## ADDENDUM 1

Bridge 26D.5 Replacement

**RE:** Adjusted Unit Price Bid Schedule, Cost Estimate, Drainage Supplemental Specifications, Type B Conduit Detail, Revised Plan Sheets

All trenches along the edge of the pavement shall be backfilled as per the Type B Conduit along Edge of Pavement Detail.

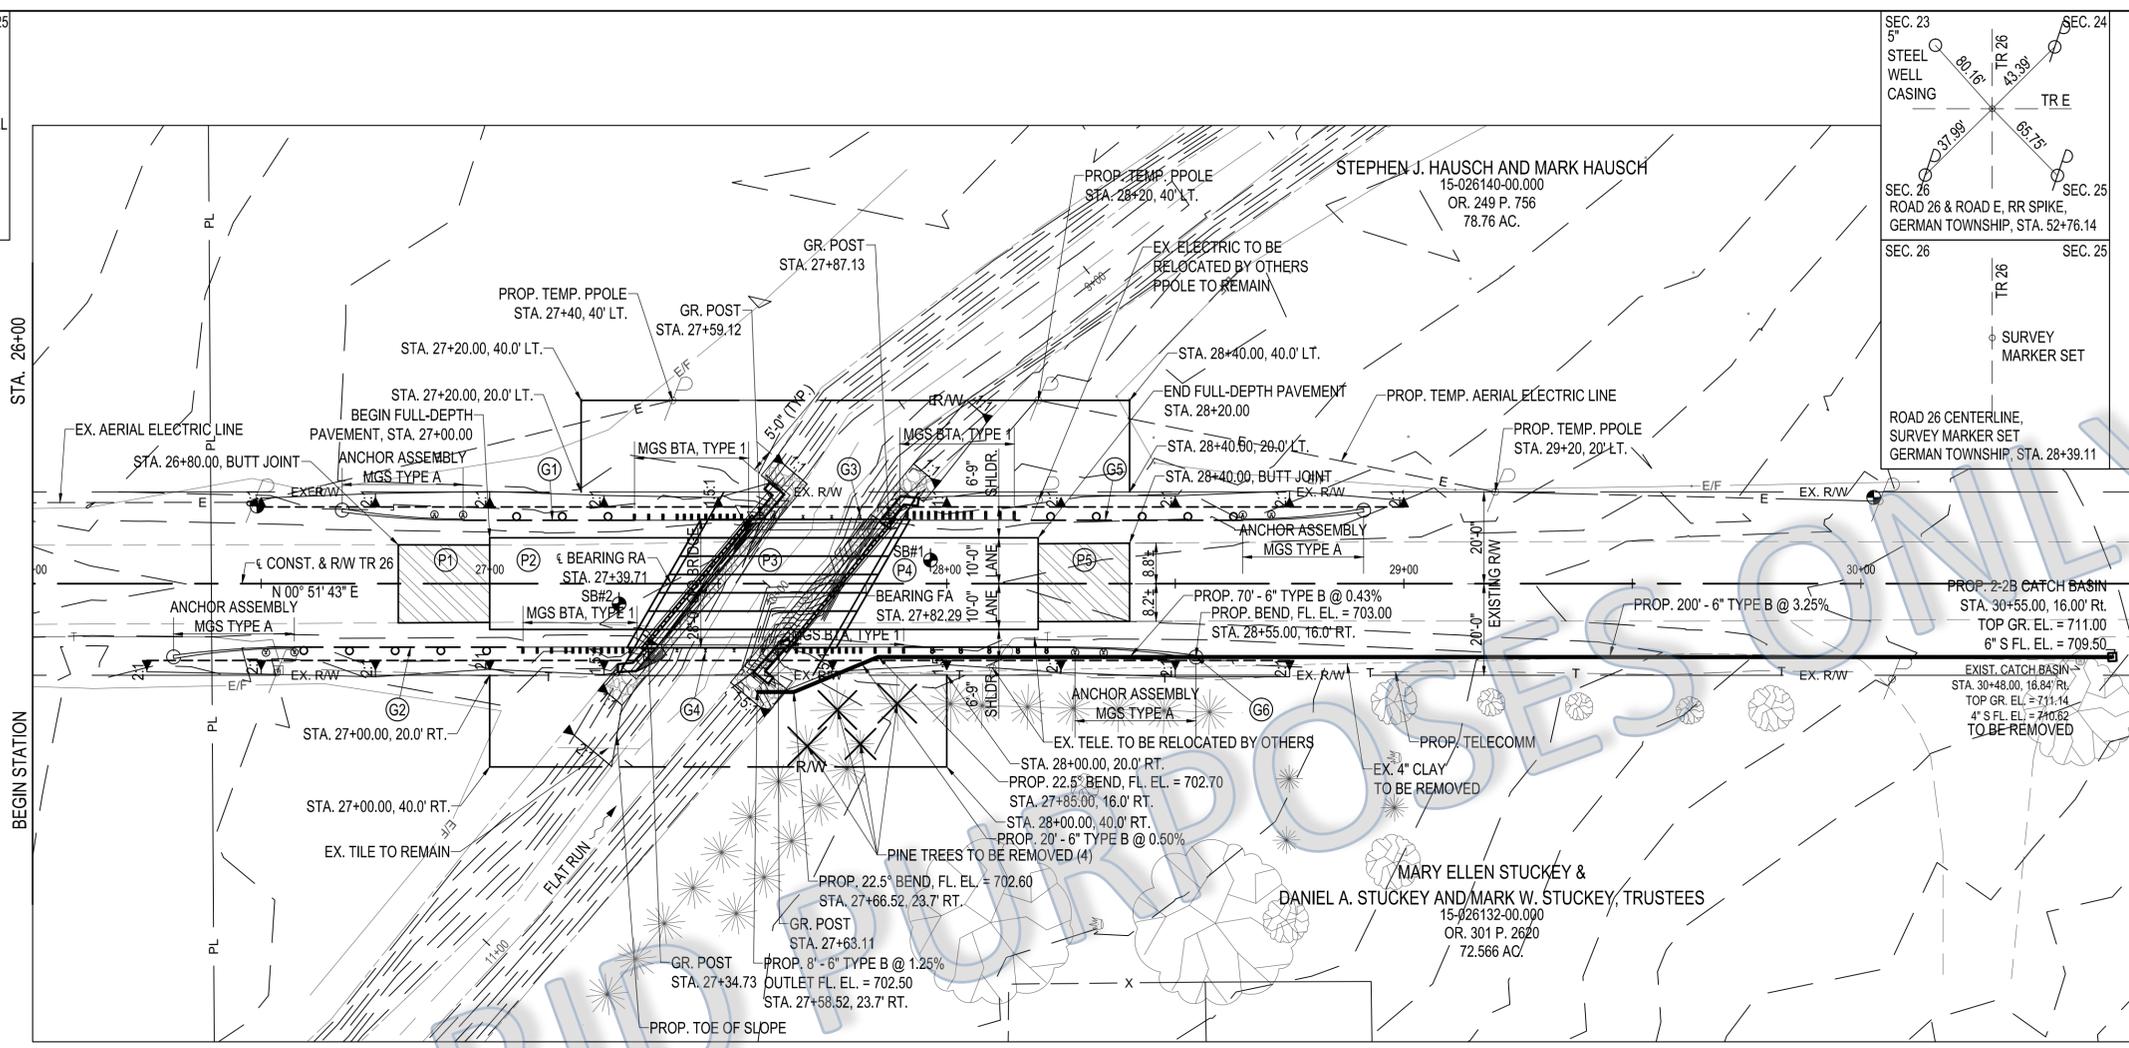
1. Adjusted Unit Price Bid Schedule  
Additional Reference Numbers 36-39 have been added to the Unit Price Bid Sheet. Please attach the updated page 9 to the proposal.
2. Cost Estimate  
Based on the additional Reference Numbers, the Engineer's Estimate has been revised to \$242,000.00. Please attach the updated page 7 to the proposal.
3. Drainage Supplemental Specifications  
Please attach the Drainage Supplemental Specifications to the proposal.
4. Type B Conduit Detail  
Please attach the Type B Conduit along Edge of Pavement Detail to the proposal.
5. Please note that Plan Sheets 5, 6, & 7 have been revised to show the additional items. These three (3) sheets do not have to be attached to the proposal.
